# PARAJET TECHNICAL ADVISORY BULLETIN

## OCTOBER 2022 - UPRATED FUEL CAP REPLACEMENT

PJ-P-10088 : Fuel Tank Cap

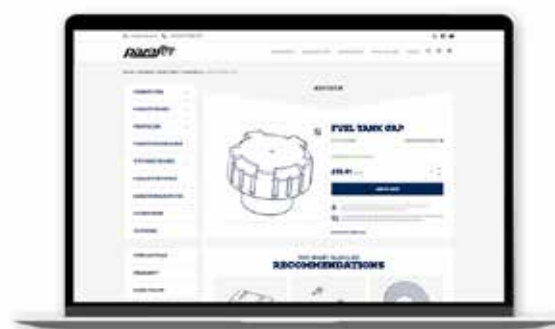
Parajet are aware of an extremely small number of cases where the fuel cap has not allowed sufficient air to enter the tank during use, creating a vacuum inside the tank and starving the engine of fuel.

An investigation was opened and following an immediate full batch inspection and review, our design engineers identified the OEM valve component at fault and have issued an in-house upgrade to better allow airflow to be drawn into the fuel tank at the optimum rate, avoiding vacuum build-up and fuel starvation to the engine.

This updated fuel cap is a direct replacement and should be immediately fitted to the tank and the old cap discarded.
